Subject: **Request for Section 401 Permit Modification** for the revised stream remediation information for the proposed Greensboro Western Urban Loop, from I-85 south of Groometown Road to south of I-40 interchange; Federal Aid project No. STPNHF-NHF-124-1(1); State Project No. 8.U492101; WBS Elements 34820.1.8 and 34820.1.10; ; TIP U-2524 AB& AC.

LOCATION: U-2524 - GREENSBORO WESTERN URBAN LOOP

TYPE OF WORK: STREAM REMEDIATION

PROJECT REFERENCE NO. U-2524BA
 SHEET NO. 2A

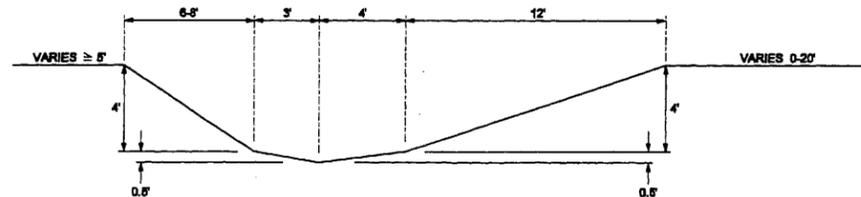
TYP. CHANNEL SECTION.
 REFER TO TYPICAL AS
 NECESSARY TO RE-GRADE
 UNSTABLE RIFFLE/RUN SECTIONS

DESIGN CRITERIA COMPARISON (RIFFLE):

ORIGINAL DESIGN	REMEDIAL DESIGN
W = 14.4 ft	W = 16.0 ft
A = 20.7 ft ²	A = 26.8 ft ²
W/D = 10.0	W/D = 9.6
d _{max} = 2.0 ft	d _{max} = 2.5 ft
Q = 94 cfs	Q = 120 cfs
